## V2500-D5 SERIES PROPULSION SYSTEMS SERVICE BULLETIN

This document transmits Revision 1 to Service Bulletin NV2500-78-0229 and Revision 1 to the Supplement

# V2500-NAC-78-0229

NACELLE - EXHAUST - TRANSLATING SLEEVE, LOWER - DRAIN TUBE MODIFICATION, THRUST  
REVERSER

Lower Translating Sleeve New Drain Installation  
Figure 1 (sheet 1)

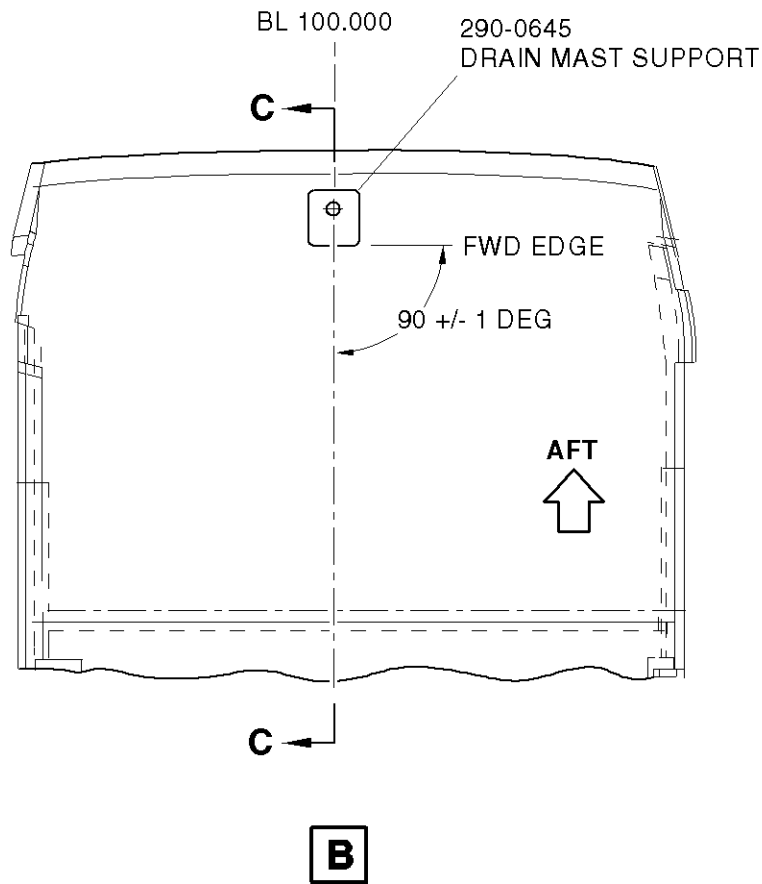
(3) Modify the lower translating sleeve to add the drain tube. (Refer to Figure 1)

- (a) To locate the drain tube, locate the drain mast support, P/N 290-0645 on the lower inner acoustic panel of the translating sleeve. Measure from the forward edge of the drain mast support 29.10 +/- 0.20 in. (739.140 +/- 5.080 mm) forward along the surface of the part at BL 100.00 to locate the center of the new drain hole. BL 100.00 runs normal (90 deg.) from center of the forward edge of drain mast support.

Lower Translating Sleeve New Drain Installation  
 Figure 1 (sheet 3)

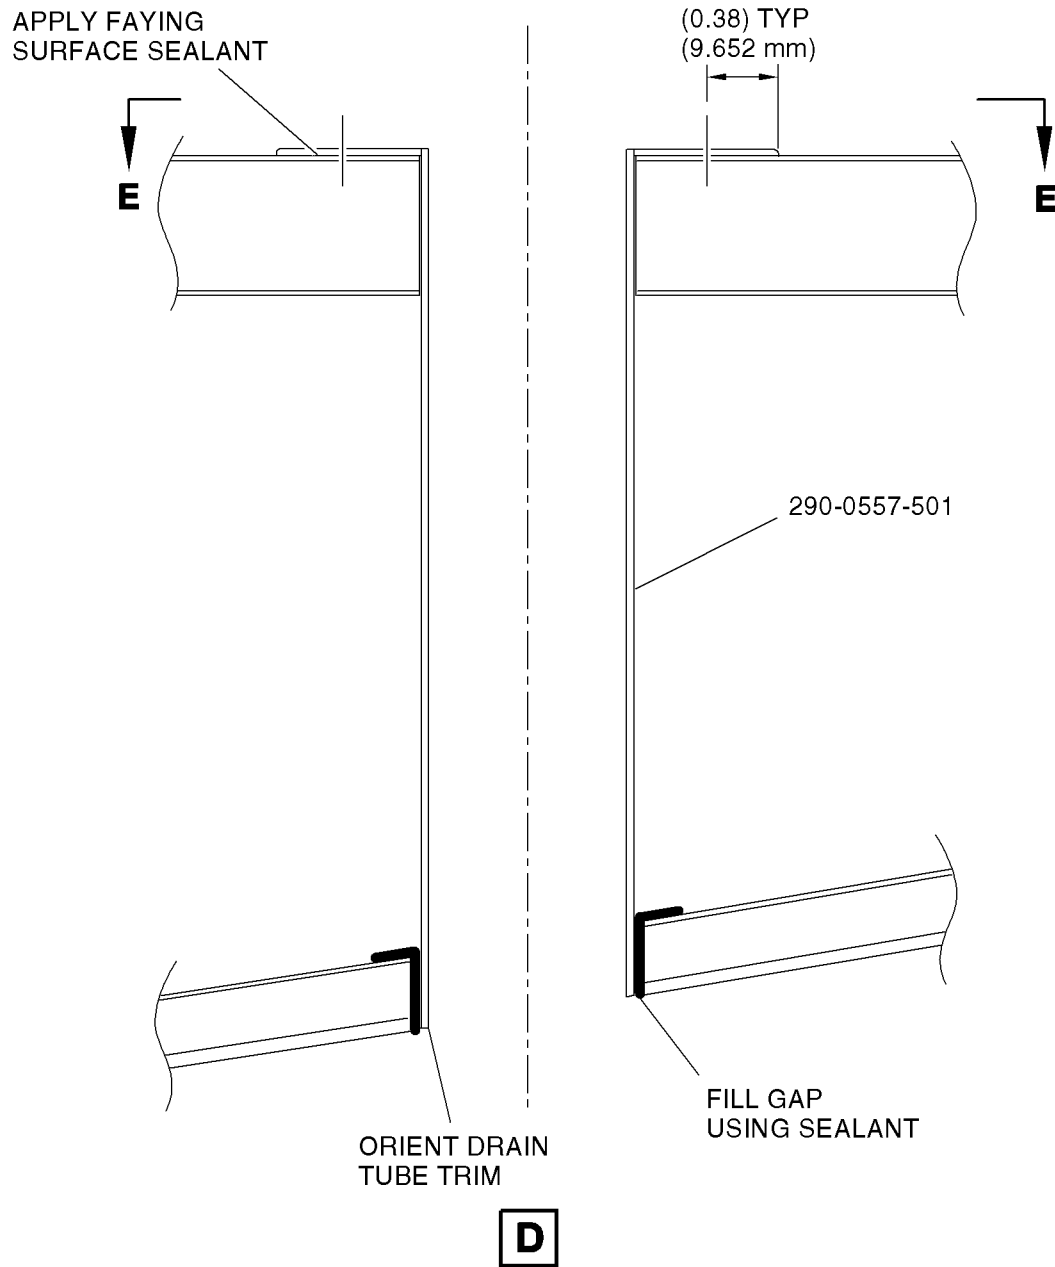
- (h) Fill exposed edges of core and cavities of inner and outer bond panels with epoxy paste adhesive EA9394 (CoMat 08-104). Cure adhesive per manufacturer's instructions. (Refer to Figure 1, Sheet 3, View C-C)

Lower Translating Sleeve New Drain Installation  
Figure 1 (sheet 4)

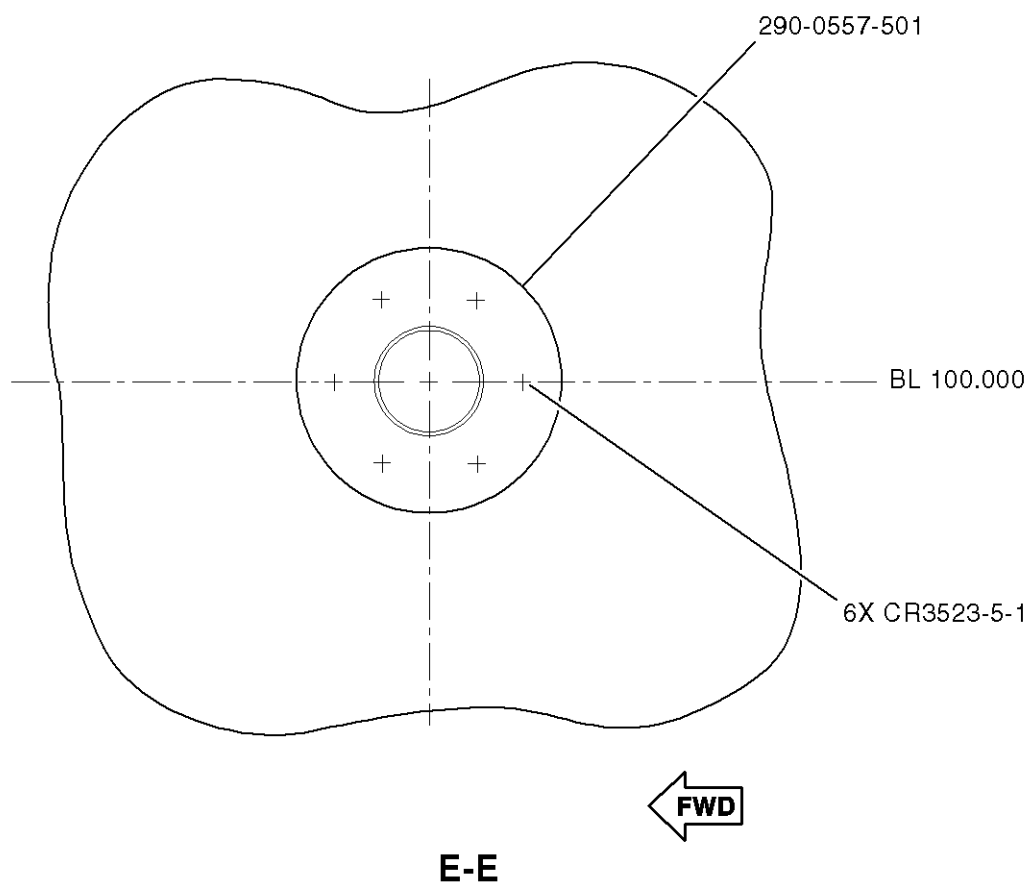
- (i) Temporarily install the new drain tube, P/N 290-0557-501 in place. Rotate tube so the end trim is even with the outer bond panel outer surface. It is acceptable to trim the end of the drain tube to match the outer bond panel outer surface to within +0.000/-0.030 in. (+0.000/-0.762 mm). (Refer to Figure 1, Sheet 4, View D)

- (n) Use masking tape (CoMat 02-178) to make a border around the drain tube flange, P/N 290-0557-501.
- (o) Apply sealant to the faying surfaces of the drain tube flange and the perforated skin (CoMat 08-141). (Refer to Figure 1, Sheet 4)

- (q) Remove the masking tape.
- (r) Fill the gap between the drain tube assembly and outer bond panel using sealant (CoMat 08-141). Cure per manufacturer's instructions. (Refer to Figure 1, Sheet 4, View D)

FIG. 2(a)

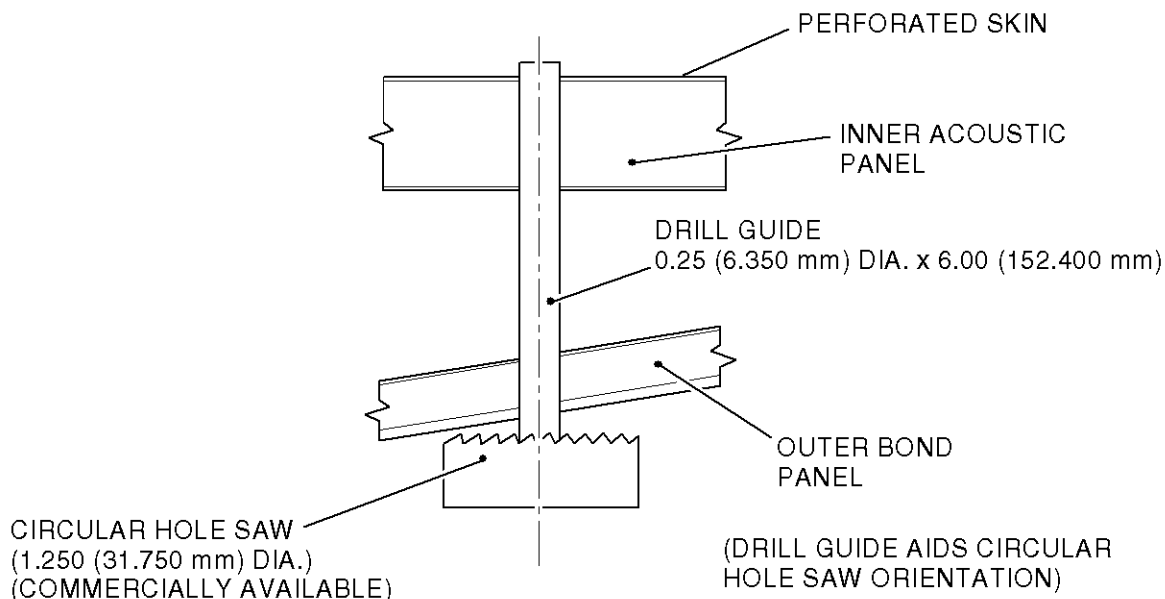
**NOTE:** When drilling through the outer bond panel, ensure that the drill orientation is as shown in Figure 2(a). The tool used to drill the final size hole (1.250 in. +0.020 /-0.010 (31.750 mm +0.508 /-0.254) diameter hole) should have a 0.25 in. (6.350 mm) diameter by 6.00 in. (152.400 mm) long drill guide.

- (c) Drill through the outer bond panel only a 1.250 in. +0.020 /-0.010 (31.750 mm +0.508/-0.254) diameter hole. See Figure 2(a) for proper tool orientation before drilling.

FIG. 2(b)

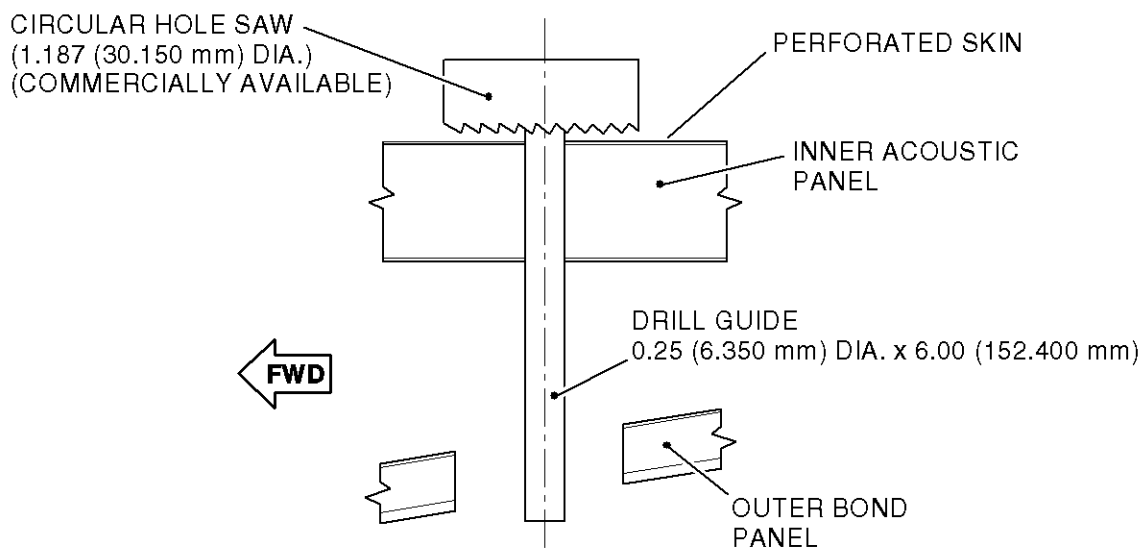
**NOTE:** When drilling through the inner acoustic panel, ensure that the drill position is normal to the perforated skin as shown in Figure 2(b). The tool used to drill the final size hole (1.187 in. +0.020 /- 0.005 (30.150 mm +0.508/-0.127) diameter hole) should have a 0.25 in. (6.350 mm) diameter by 6.00 in. (152.400 mm) long drill guide. A shorter length drill guide may be used for this operation only.

- (d) Drill through the translating sleeve inner acoustic panel only normal to the perforated skin a 1.187 in. +0.020 /-0.005 (30.150 mm +0.508/-0.127) diameter hole. See Figure 2(b) for proper tool orientation before drilling.

**CAUTION:** DRILL THROUGH THE PERFORATED SKIN ONLY, AND NOT THROUGH THE INNER BOND PANEL SOLID SKIN. SEE FIG. 2(B).
